MONITORING YEAR 3 ANNUAL REPORT

KEY MILL MITIGATION SITE

RE: Final MY3 Report Review
Key Mill Mitigation Site, Surry County
Yadkin River Basin – HUC 03040101
DMS Project ID No. 100025 / DEQ Contract #7180

Wildlands Engineering, Inc. (Wildlands) has reviewed the Division of Mitigation Services (DMS) comments from the Draft MY3 Monitoring Report for the Key Mill Mitigation Site. The report has been updated accordingly. The Final MY3 Monitoring Report and the digital are included. Wildlands' responses to DMS' report comments are noted below in *italics*.

APPENDIX A. Visual Assessment Data

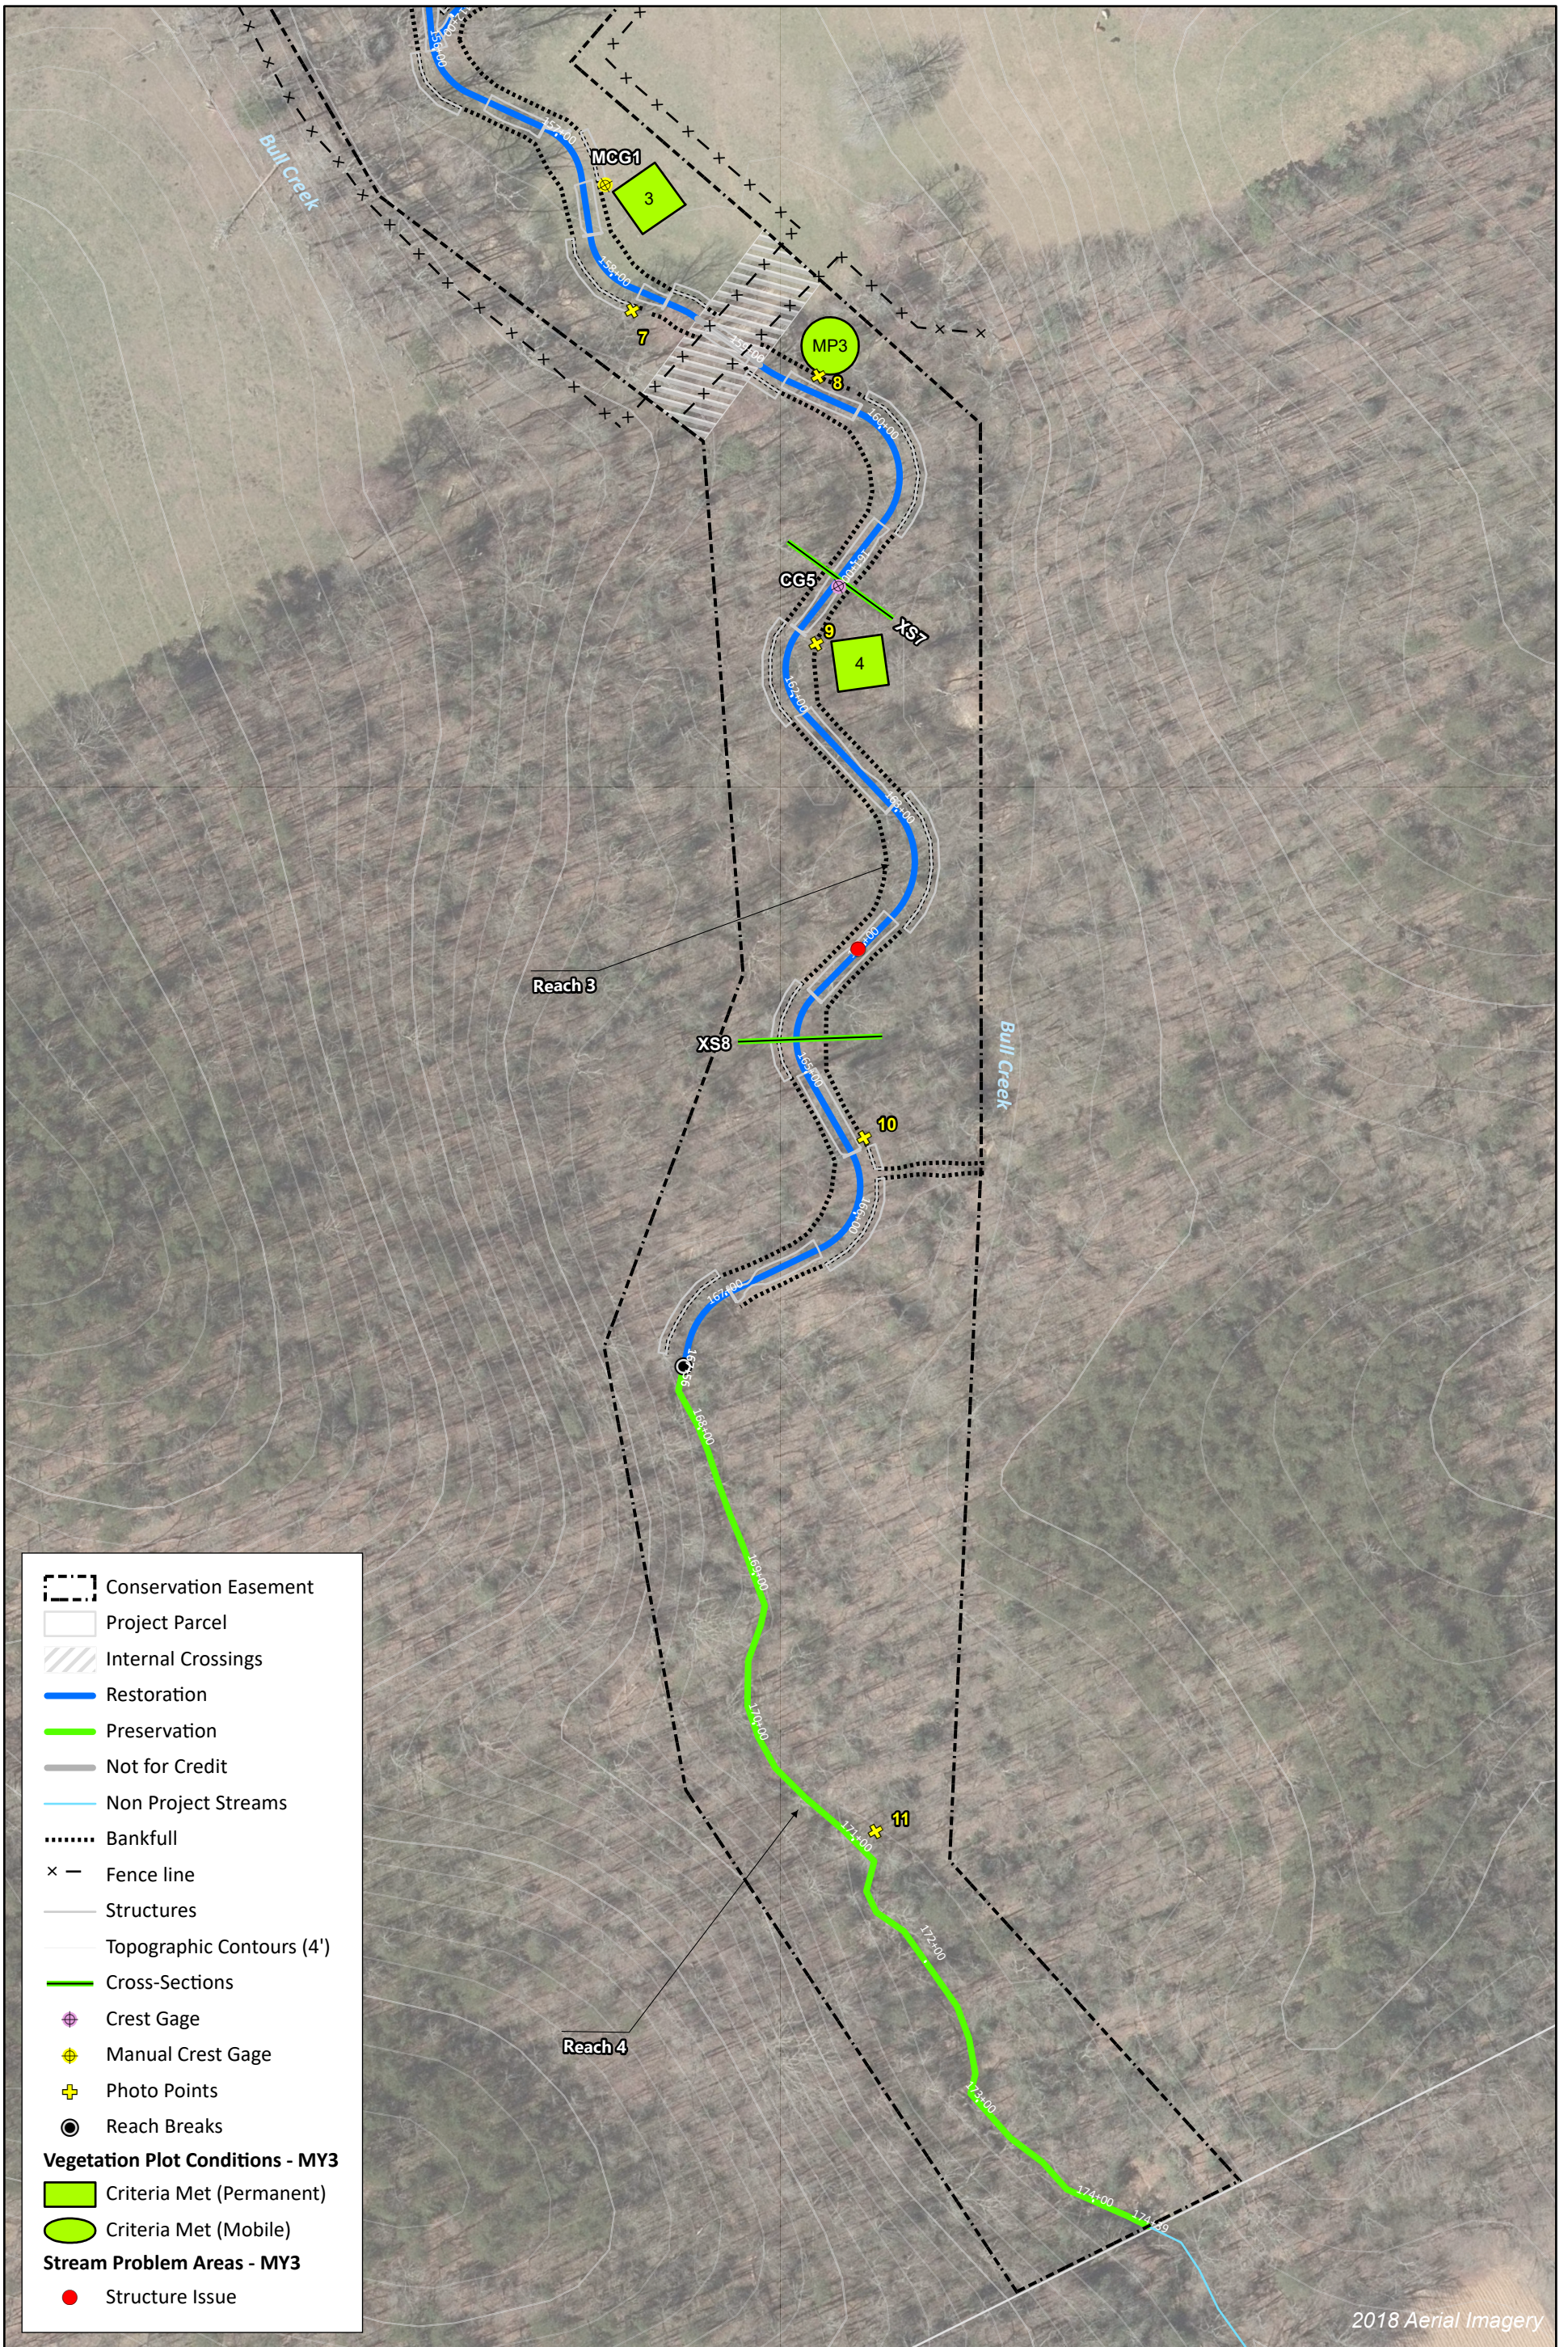
DMS comment: CCPV: Figure shows the fence line within the conservation easement in numerous locations. Please verify no fence is installed within the conservation easement and revise layer, as necessary.

DMS comment: CCPV: Please include the piping structures on Bull Creek R3 on CCPV. Currently, an area of erosion is shown in the general location.

Wildlands' response: Wildlands verified that no fencing has been installed within the conservation easement (CE). The issue is with the GIS symbol used to reflect the placement of the fence. The symbol has been corrected and updated, and it now correctly reflects that the alignment of the fence is not within the CE boundary.

Wildlands' response: The CCPV figures depicted the issue on Bull Creek Reach 3 as scour within the riffle since the piping and the displacement of each log is part of a single riffle structure; however, after a brief discussion with DMS, it was decided to document the issue as part of a single engineered structure. Therefore, the symbol within the CCPV figure has been changed to depict it as a structure issue and recorded on Table 4d. under the channel sub-category as a piping and overall integrity issue, rather than a bed stability degradational issue. Both Table 4d and Figures 1a – 1c have been updated to reflect this change.
